Re: Service Bulletin/Manual Submission

MC 09-03

**MODEL:** 2008 and 2009 KLR™650 (KL650E8F/L, KL650E9F/L)

**TITLE:** MUFFLER MOUNT BOLT REPLACEMENT

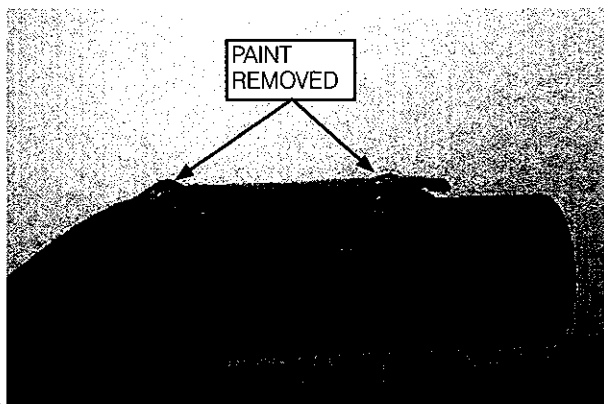
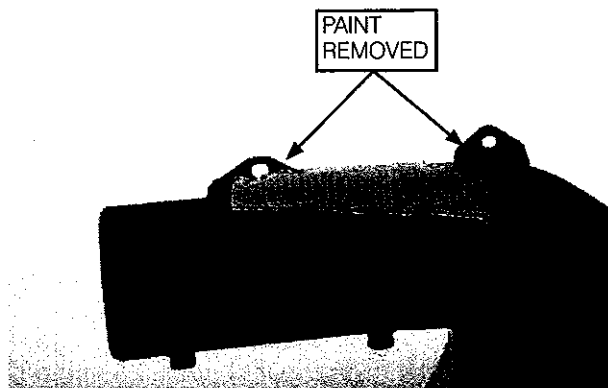
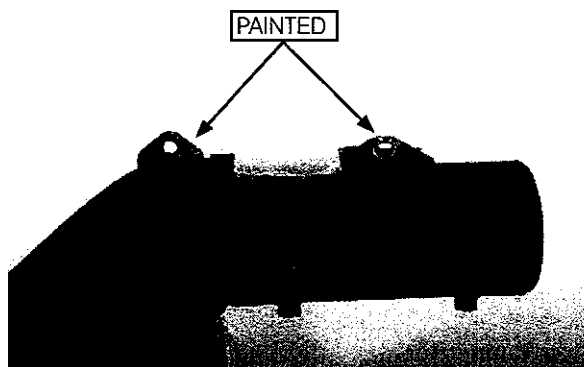
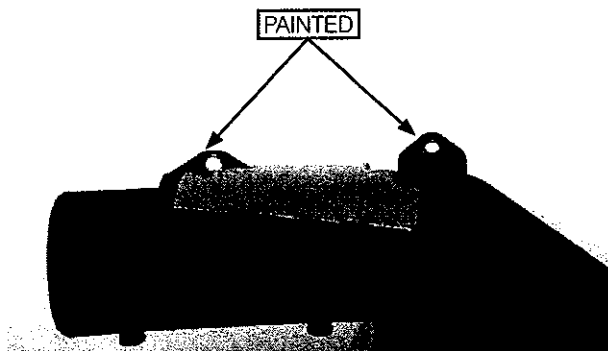
- Remove the muffler as outlined in chapter 5 of the service manual.
- Discard the muffler mount bolts and nut.
- Retain the muffler joint clamp and bolt.
- Discard the muffler joint gasket.
- Remove the paint from both sides of each (2) muffler mount tabs as shown. Use 100 grit sandpaper. Be sure to remove any welding spatter from the mount tabs.

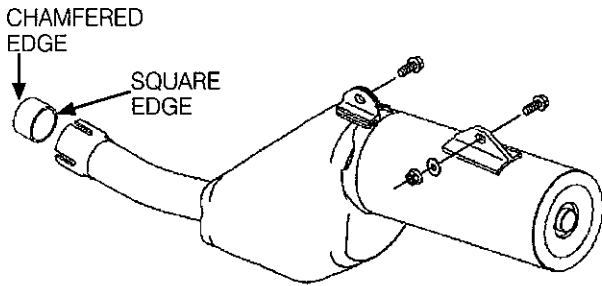
- o Install the chamfered edge of the muffler joint gasket facing forward.

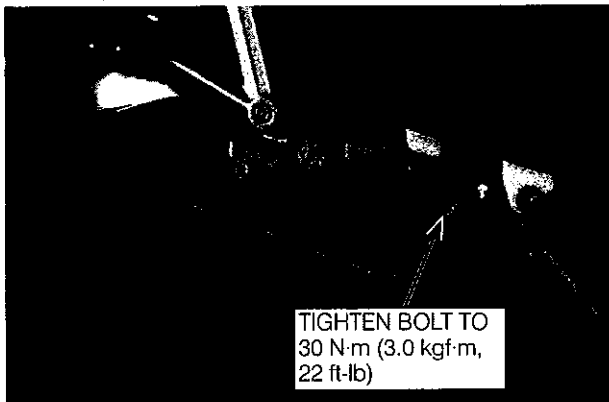
- o Install both bolts in the muffler mounts before tightening to insure the muffler is properly aligned..

- Tighten the forward muffler mount bolt to 30 N·m (3.0 kgf·m, 22 ft-lb).

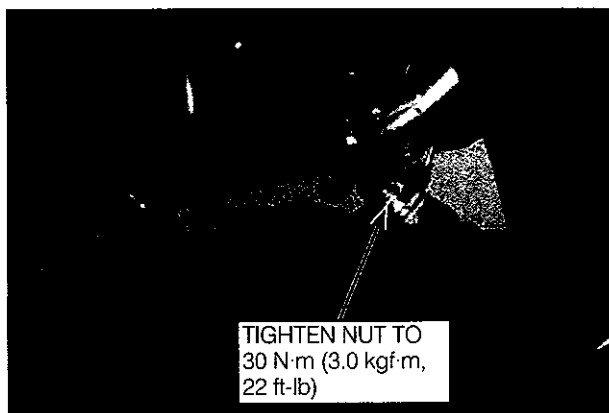
- Tighten the muffler mount bolt and nut to 30 N·m (3.0 kgf·m, 22 ft-lb).

- Tighten muffler joint clamp bolt to 21 N·m (2.1 kgf·m, 15 ft-lb).

- Change the "muffler body mounting bolts" and "muffler body mounting nut" torque values in your service manual (99924-1384-01) to 30 N·m (3.0 kgf·m, 22 ft-lb) on pages 2-8, 5-5, and 5-43.
- Change the "muffler body mounting bolts" and "muffler body mounting nut" torque value in your service manual (99924-1384-02) for KL650E8F to 30 N·m (3.0 kgf·m, 22 ft-lb) on pages 2-7, 5-5, and 5-43.
